### Addendum No. 1

**PROJECT:** CHRYSLER PUMP STATION REHABILITATION PROJECT  
PROJECT NUMBER 20-056

**OWNER:** CITY OF MENLO PARK

SHEET 2 OF 3

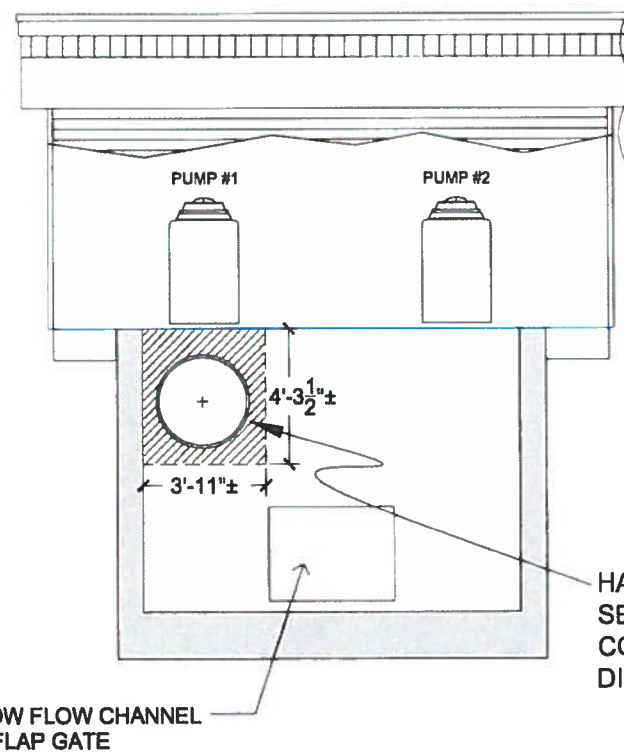
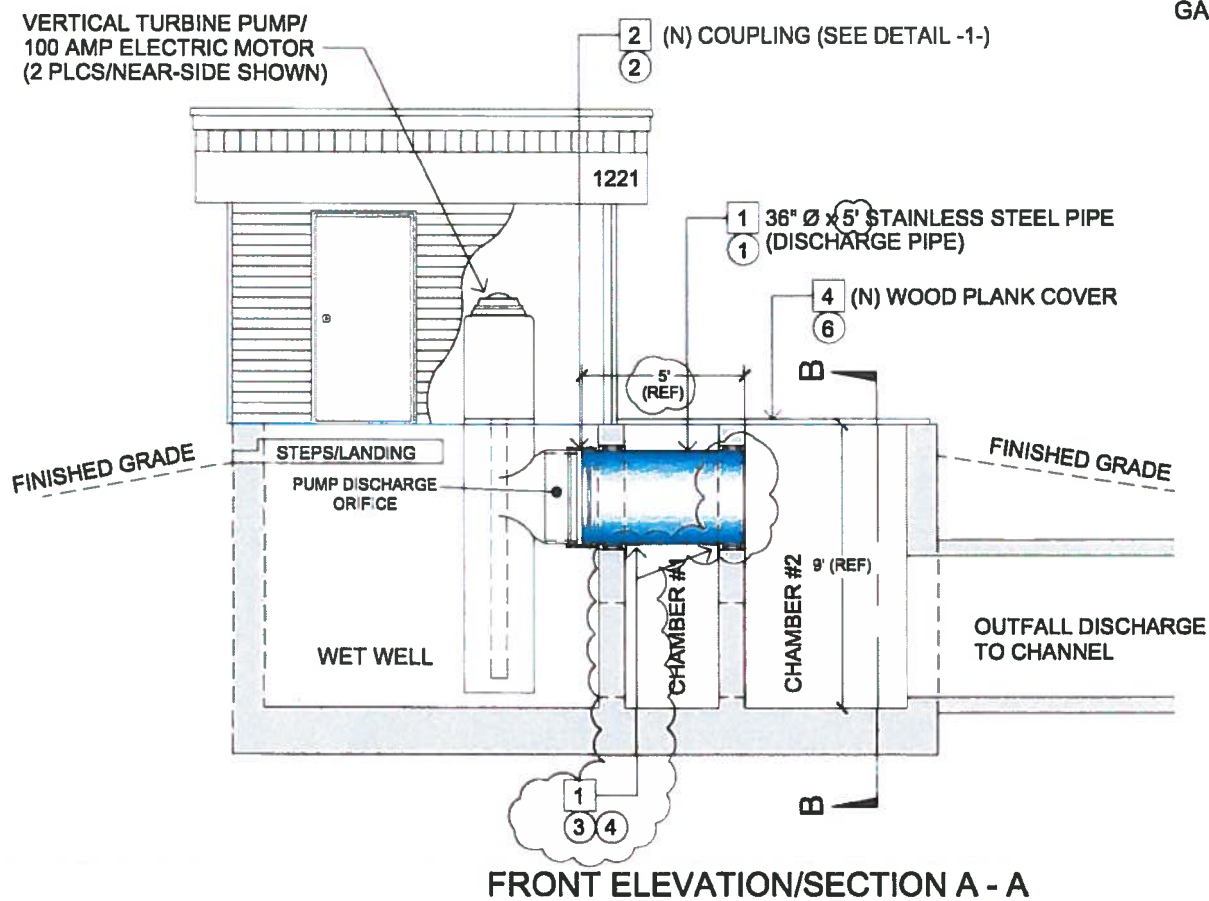
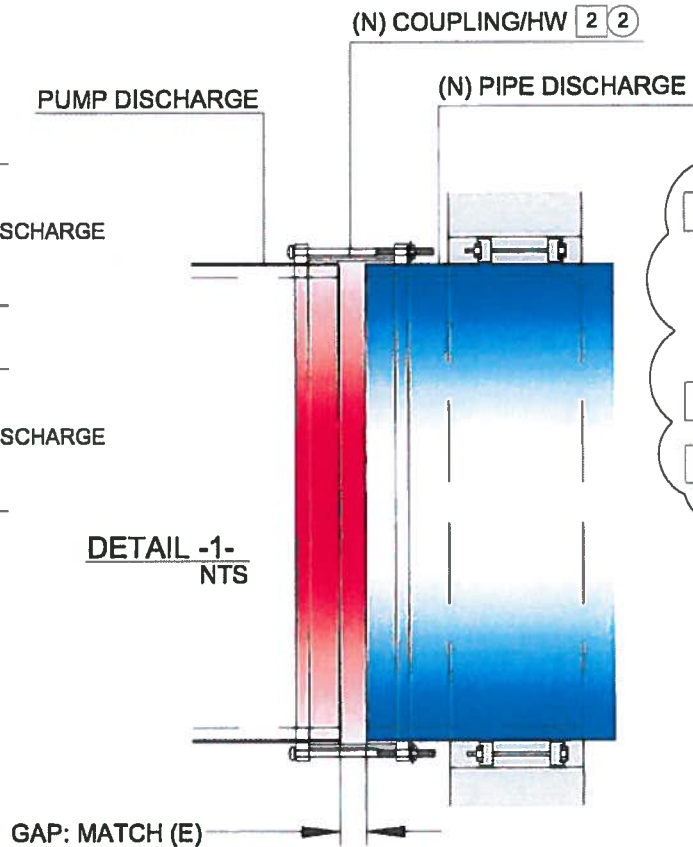
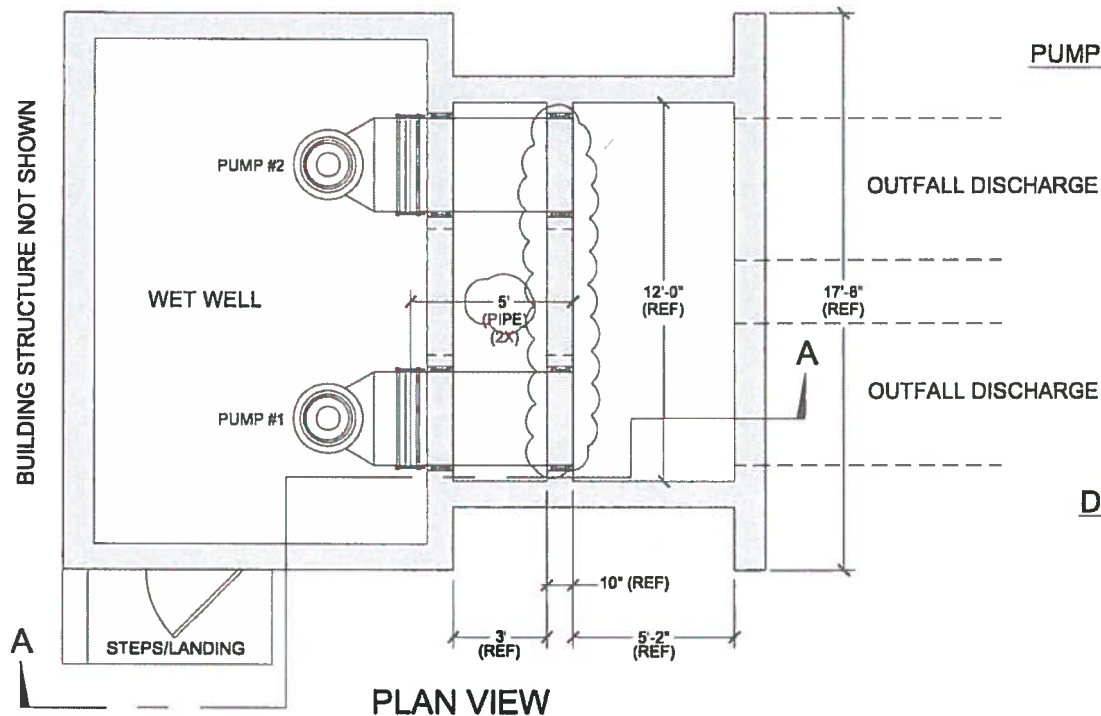
**Plans (refer to clouded revisions to sheet 2 of 3 dated 09.19.11, 1 page total):**

1. All revisions to plans have been indicated with revision clouds to sheet 2 of 3.

- 1 DEMOLISH AND REMOVE THE EXISTING DILAPIDATED PUMP DISCHARGE PIPE MATERIAL. REPLACE WITH NEW 36 INCH DIAMETER STAINLESS STEEL PIPE (ITEM 1). FIELD VERIFY LENGTH PRIOR TO INSTALLATION AND ASSEMBLY. INSTALL "LINK-SEAL" PIPE SEAL, ITEM 3, 4 PLCS, PER MANUFACTURER'S ASSEMBLY INSTRUCTIONS. INSTALL ANGLE BRACKET, ITEM 4, AT LOCATIONS NOTED, 4 PLCS; SEE SHEET 3 OF 3, DETAILS S1 AND S2.
- 2 REMOVE EXISTING DISCHARGE PIPE COUPLER AND REPLACE WITH NEW COUPLING (ITEM 2). MAINTAIN AN EXPANSION GAP BETWEEN THE PUMP DISCHARGE ORIFICE AND DISCHARGE PIPE. INSTALL PER MANUFACTURER'S INSTRUCTIONS. PER DETAIL -1-
- 3 REMOVE EXISTING FLAP GATES RESIDUAL MATERIAL.
- 4 REMOVE AND REPLACE THE EXISTING WOOD PLANK COVER (ITEM 6) WITH PRESSURE TREATED LUMBER TO MATCH (E) DIMS.
- 5 CHAMBERS TO BE CLEANED AND DEBRIS REMOVED FOLLOWING CONSTRUCTION.

HATCHED AREA DELINEATES (E) CONC. WALL TO BE SAWCUT. SEE SHEET 3 OF 3, DETAILS 1/S1 AND 2/S2 FOR STRUCTURAL CONSTRUCTION OF CONCRETE WALL AND INSTALLATION OF DISCHARGE PIPE, LINK-SEALS AND ANGLE SHELF; TYP (4 PLCS).
